F.2 1737 Rockland Avenue: Rezoning Application No. 00755 and Development Permit with Variances Application No. 000585 (Rockland)

To: Committee of the Whole **Date:** October 14, 2021
From: Karen Hoese, Director, Sustainable Planning and Community Development
Subject: Rezoning Application No. 00755 for 1737 Rockland Avenue

1737 Rockland Ave
Rezoning No.00755

PROPOSED DEVELOPMENT FOR 1737 ROCKLAND AVE SITE PLAN

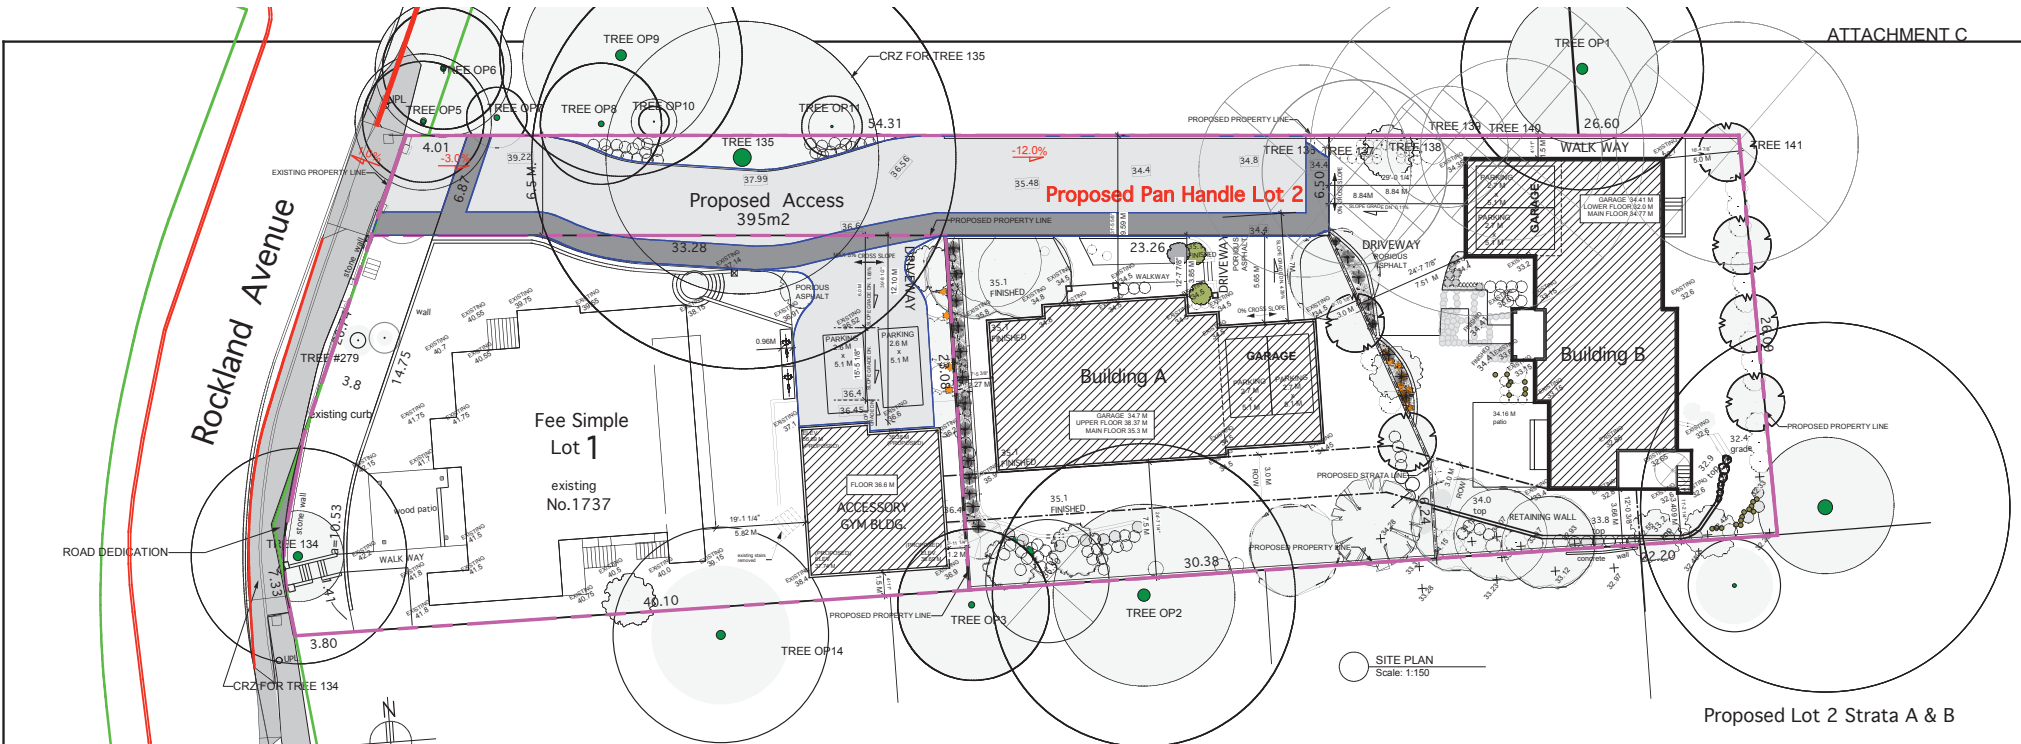
Comments: ZONING PLAN CHECK:

1. The parking stall on lot 1 does not have adequate clearance behind it. Move the stall over so that the full 7.0m is behind the stall.
2. Ensure that the lower of the existing or proposed grade is used at each point for the accessory building average grade calculations. At some points the existing grade are lower than the proposed grade used. Ensure the height is updated. (ALSO SEE SHEET 4)

3. change the arrow with the wording to be to the left to denote the red line.
4. correctly show the road dedication area to match Sheet 4 of 5 and C1.
